RE: 6/2021/2207/MAJ – Campus West, The Campus, Welwyn Garden City, AL8 6BX

Conisbee have been appointed by Welwyn Hatfield Borough Council (WHBC) to produce a Flood Risk Assessment (FRA) and Drainage Strategy to support a planning application for a new multi-storey decked car park at the site of the existing Campus West Car Park.

This note has been prepared to address comments raised by Hertfordshire County Council (HCC) Lead Local Flood Authority (LLFA) regarding the application, refer to correspondence attached at **Appendix A**.

Drawing Number
TS20-006-4

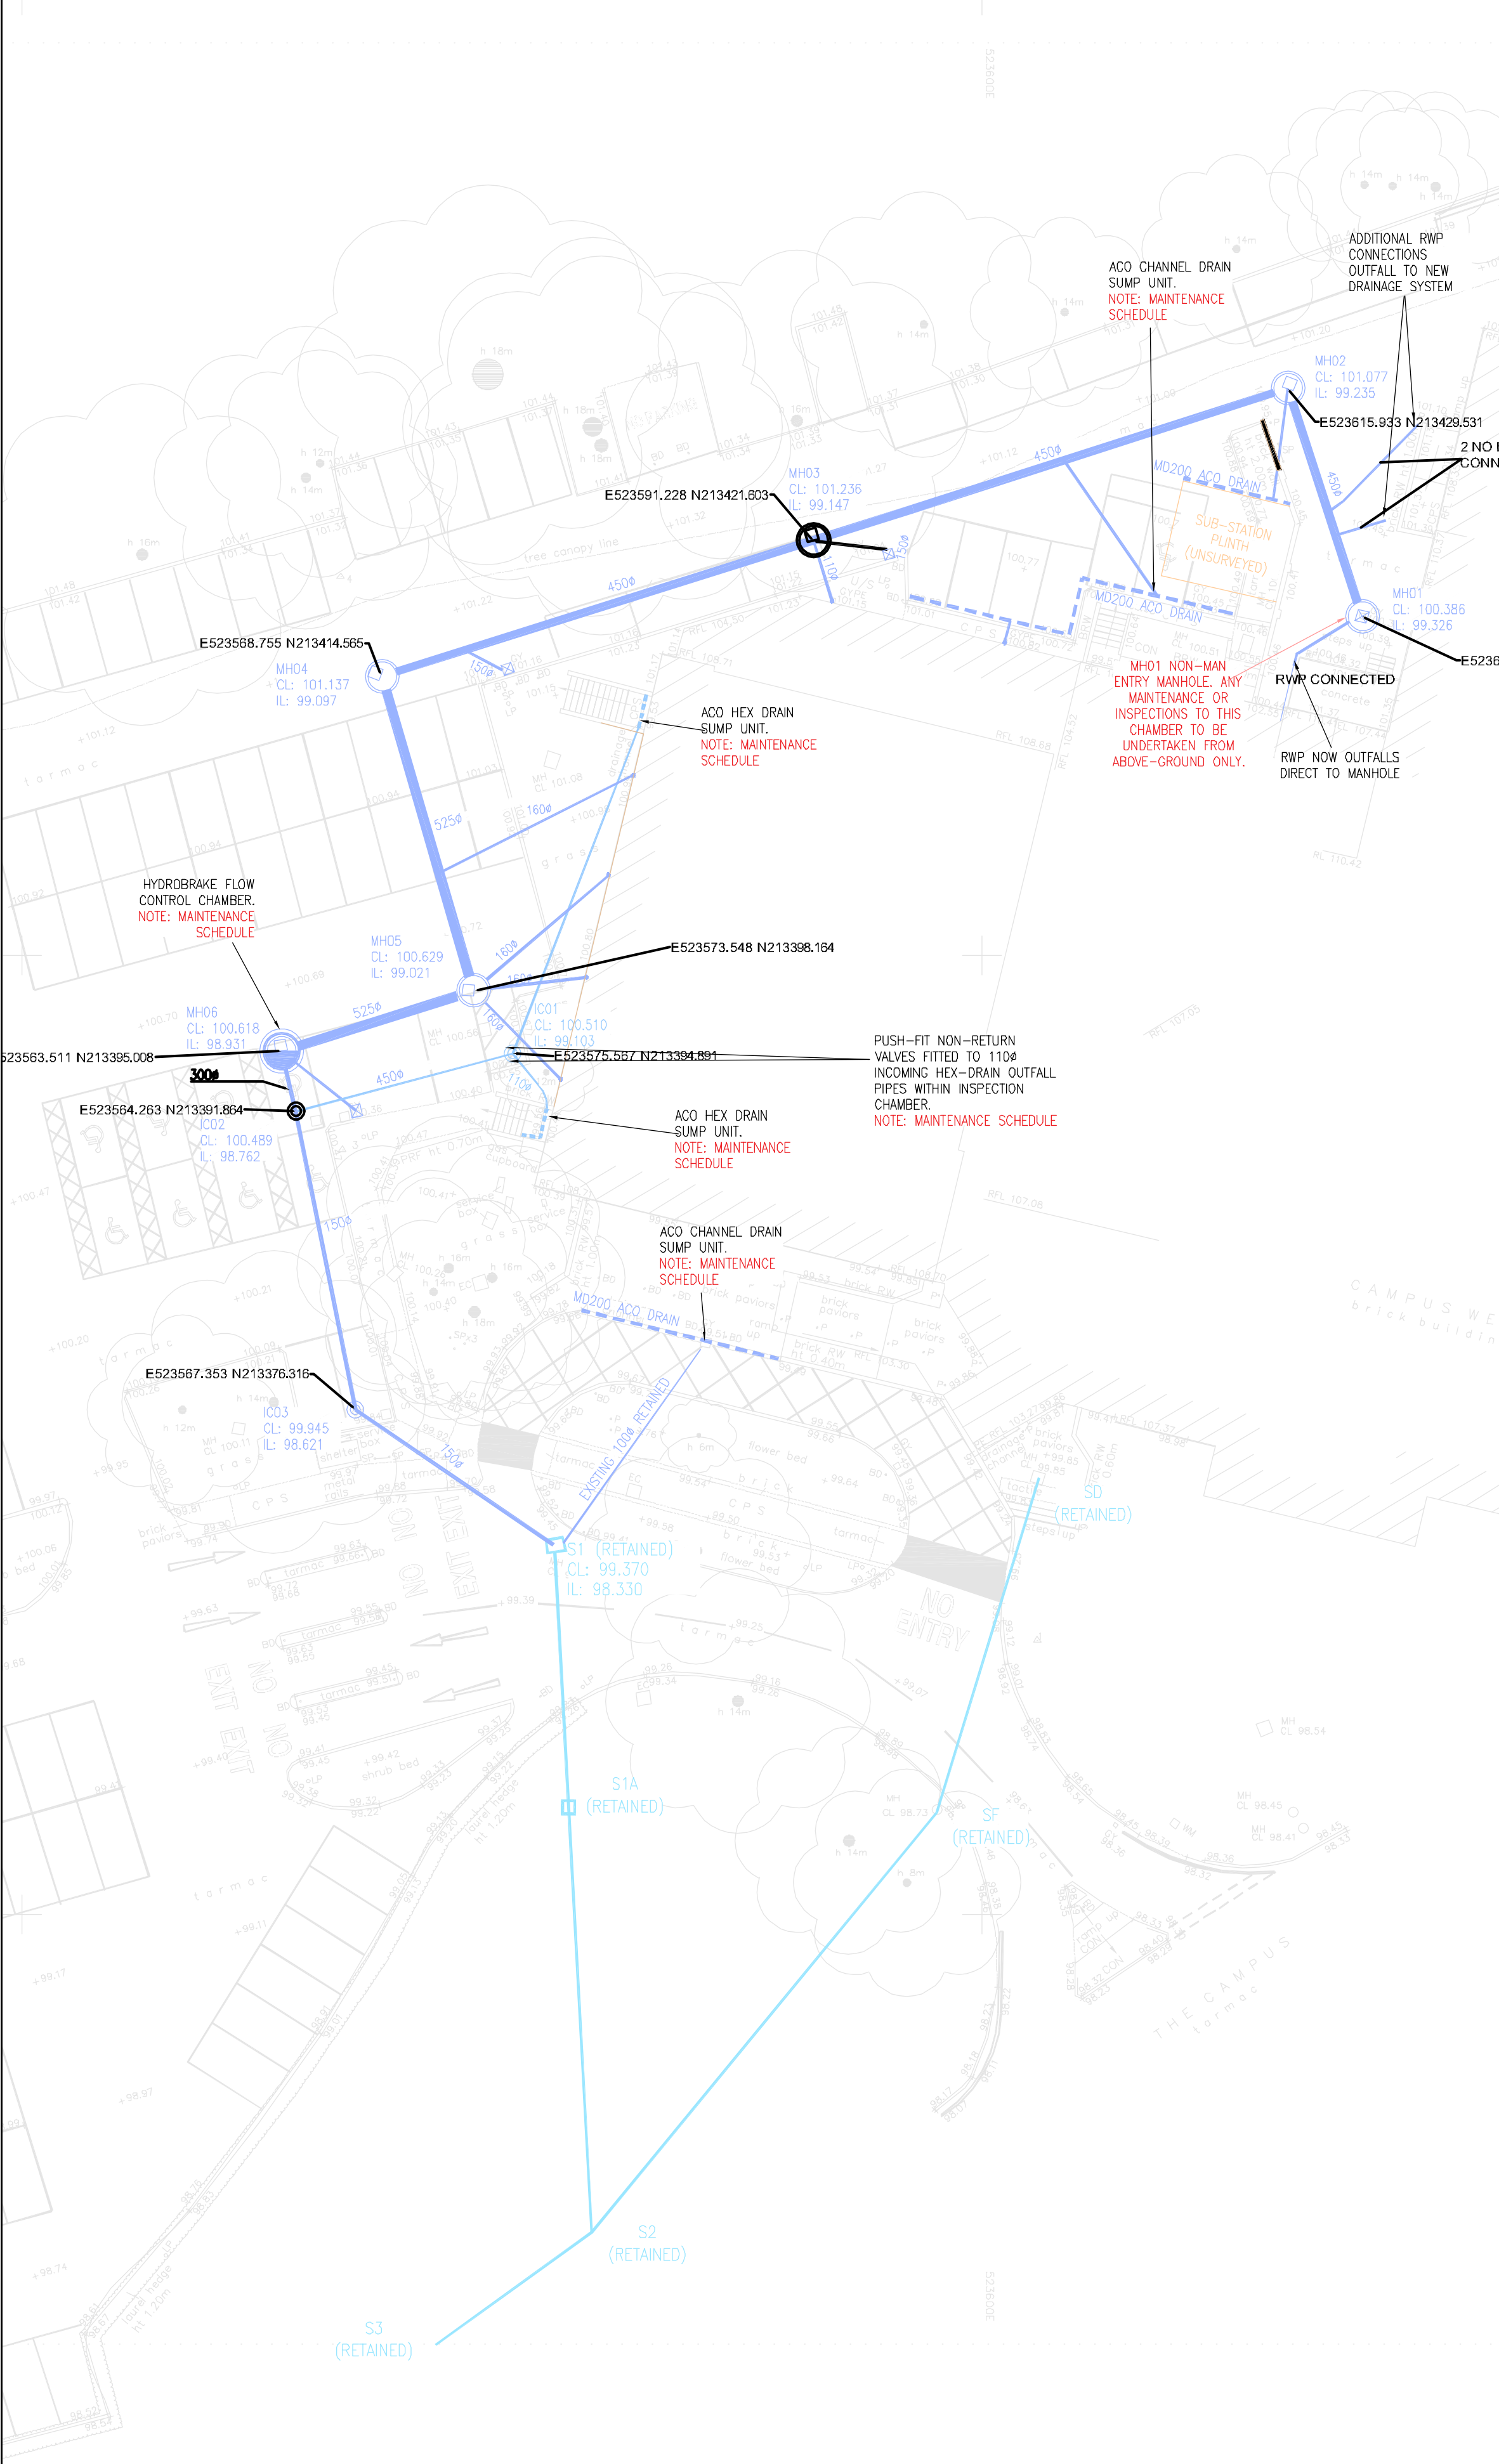
We understand that the site plan has been updated since the Pre-Application stage where the LLFA were consulted. We note there is additional area included in the site layout now and the drainage strategy has not been updated to include the additional area.

The applicant should update the drainage strategy to include the additional site area as we would expect the applicant to actively drain the entire site area. If there is existing site drainage that is to be reused for the additional site area this should be submitted to the LPA.

It is proposed that the existing drainage systems in these areas are retained. GPR survey has been undertaken by Terrain Survey which confirms the layouts of the existing surface water systems in these areas. Refer to drawing TS20-006-4 attached at **Appendix C**.
